Access Compliance Report Public Rights-of-Way (Curb Ramps)

Main Street: WHEMBLY_DR Cross Street: DODGE_AVE Location: SW

ADA ID: RPAT211018112732 Ramp Type: Type 3 - Combination 1 Initial Pass/Fail: Pass Overall Compliance: No Severity Score: 4

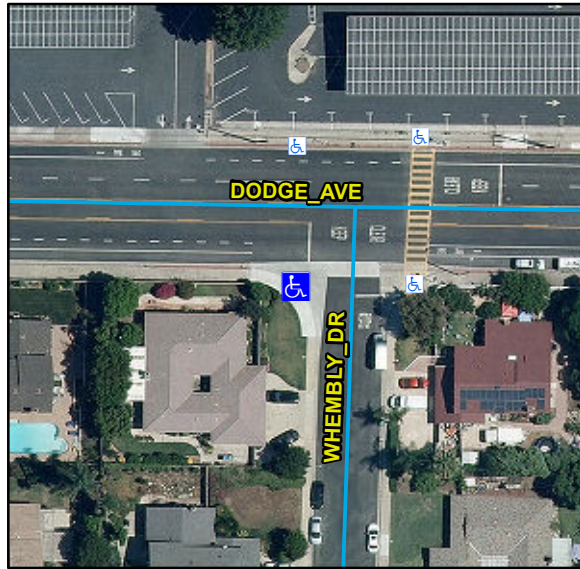
Remove & Replace Landing.

R304.2.1, STD 1115
